Submission to Department of Planning Ardmore Park Quarry – Modification #3

I am the landowner of the property at 5525 Oallan Ford Road, which is immediately adjacent the Ardmore Quarry Bungonia bypass road.

Approved bypass
road route

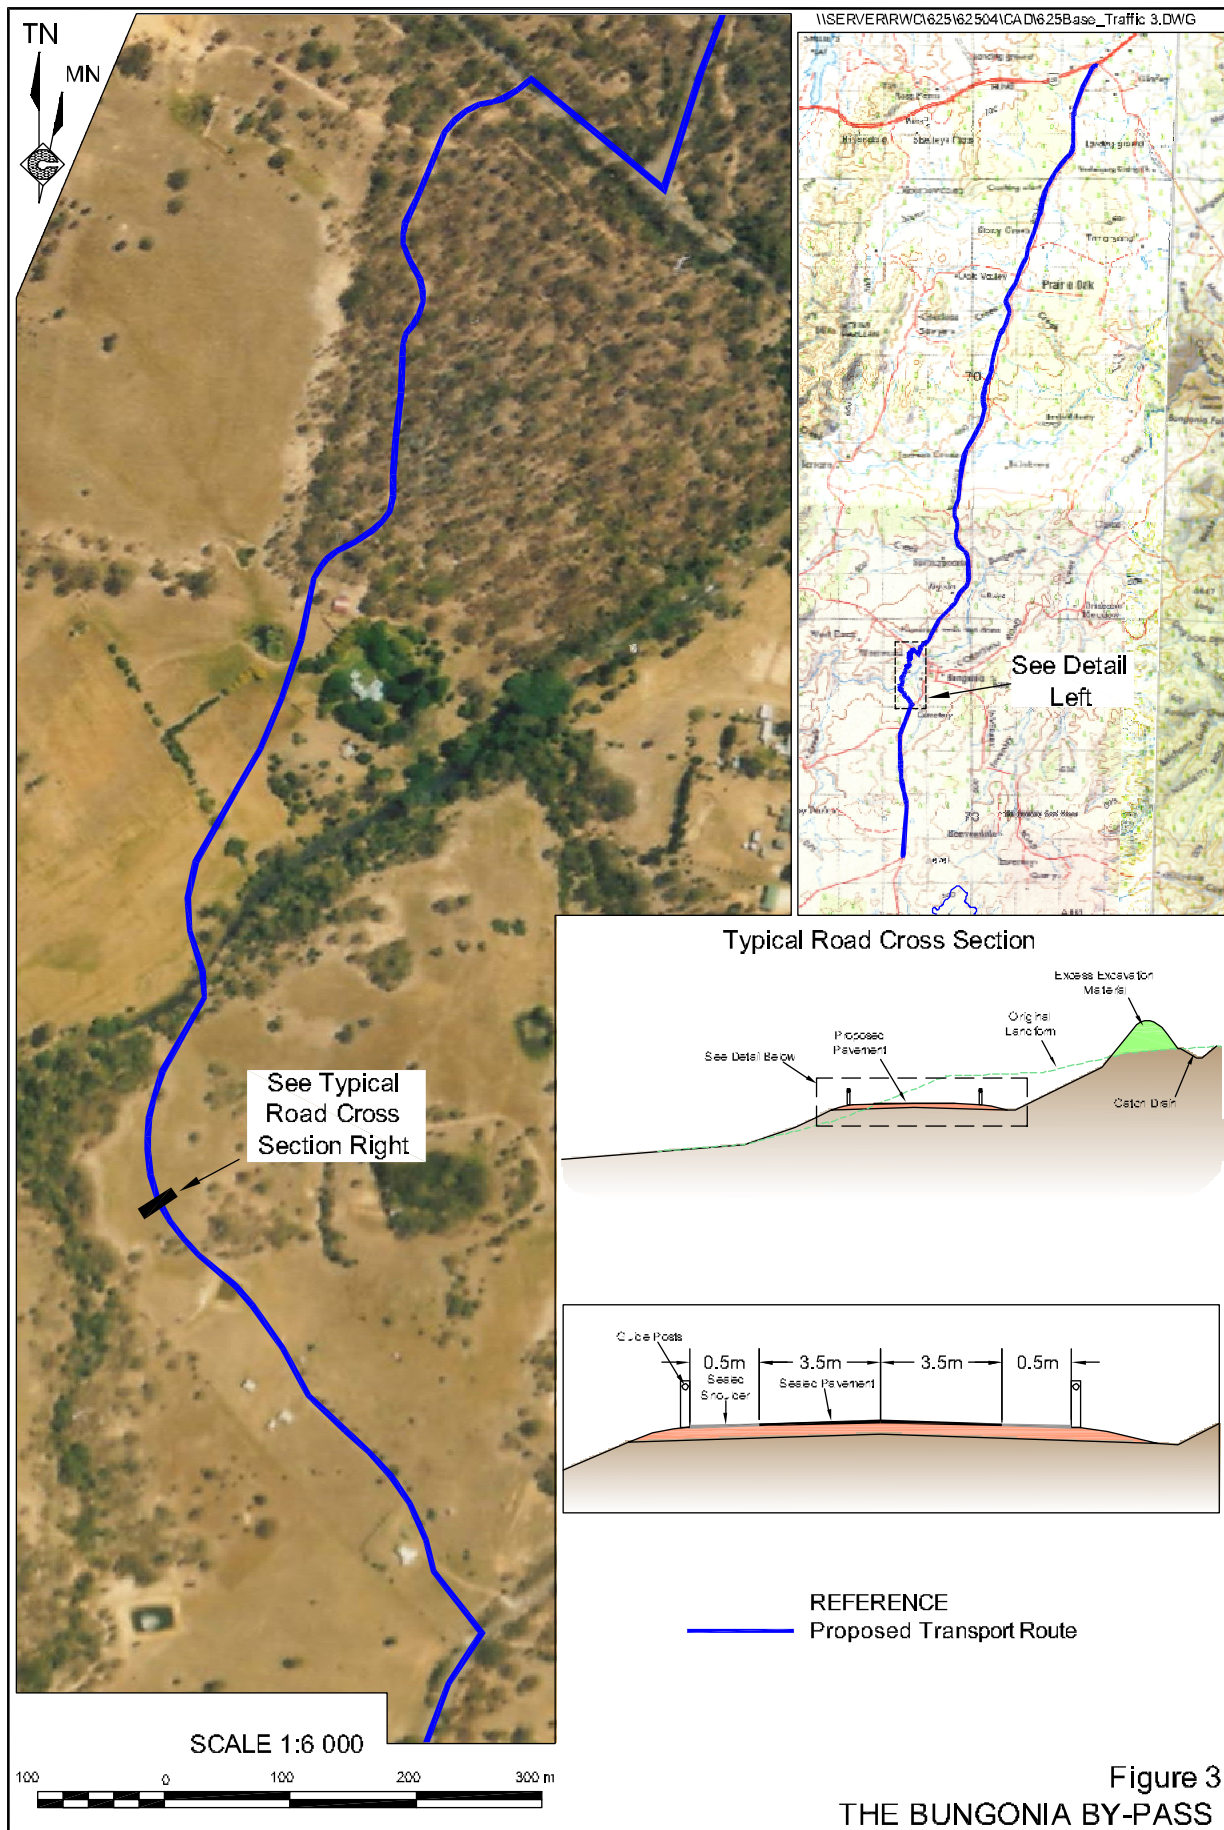
The Bungonia bypass road has not been build in accordance with the original drawings. It is closer to the village and passes across the saddle between the two hills that shielded my property and the village from direct traffic noise. Furthermore, earth barriers proposed on the original drawings have not been installed.

The approved route and cross sectional details of the road are shown in Attachment_1.

However the actual route is different to that approved and is shown in Attachment_2. The road is not only closer to the Bungonia village, but also passes a saddle that provides a direct sound path from the trucks to my house site and the village.

Furthermore, the soil bunds specified in the original plans, as shown in the typical road cross section in Attachment_1, have not been built. These bunds have been omitted from the drawings submitted with the latest proposal.

As a minimum, a condition should be applied requiring the noise be remodelled to assess the true impact of actual road location on the surrounding properties and that the bunds be built, particularly across the saddle that funnels the noise to the village, before further usage of the bypass road allowed or traffic hours increased.
